# Intel<sup>®</sup> Pentium<sup>®</sup> III Processor Specification Update

Release Date: November 2004

Document Number: 244453-051

The Pentium<sup>®</sup> III processor may contain design defects or errors known as errata which may cause the product to deviate from published specifications. Current characterized errata are documented in this Specification Update.

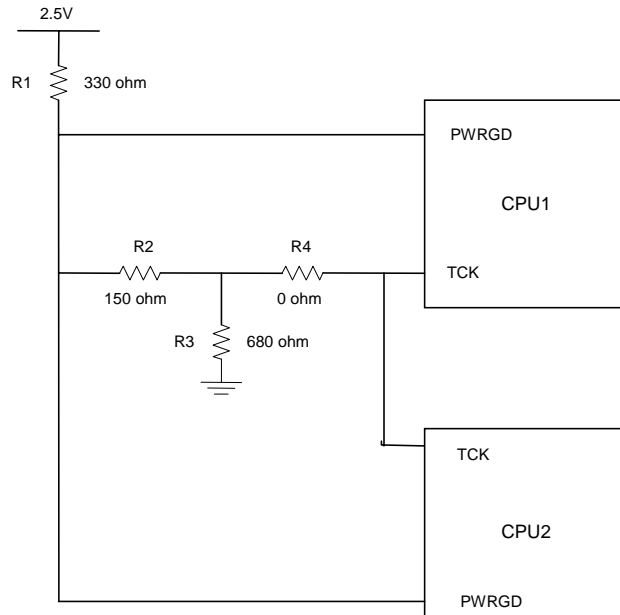
**Problem:** The internal control register bit responsible for operation of the Thermtrip circuit functionality may power up in a non-initialized state. As a result, THERMTRIP# may be incorrectly asserted during de-assertion of RESET# at nominal operating temperatures. When THERMTRIP# is asserted as a result of this erratum, the processor may shut down internally and stop execution but in few cases continue to execute.

**Implication:** This issue can lead to intermittent system power-on boot failures. The occurrence and repeatability of failures is system dependent, however all systems and processors are susceptible to failure. In addition, the processor may fail to stop execution during the event of a valid THERMTRIP# assertion resulting in the potential for permanent processor damage.

**Workaround:** To prevent the risk of power-on boot failures or catastrophic thermal failures, a platform workaround is required. The system must provide a rising edge on the TCK signal during the power-on sequence that meets all of the following requirements:

- Rising edge occurs after Vcc\_core is valid and stable
- Rising edge occurs before or at the de-assertion of RESET#
- Rising edge occurs after all Vref input signals are at valid voltage levels
- TCK input meets the Vih min and max spec as mentioned in EMTS
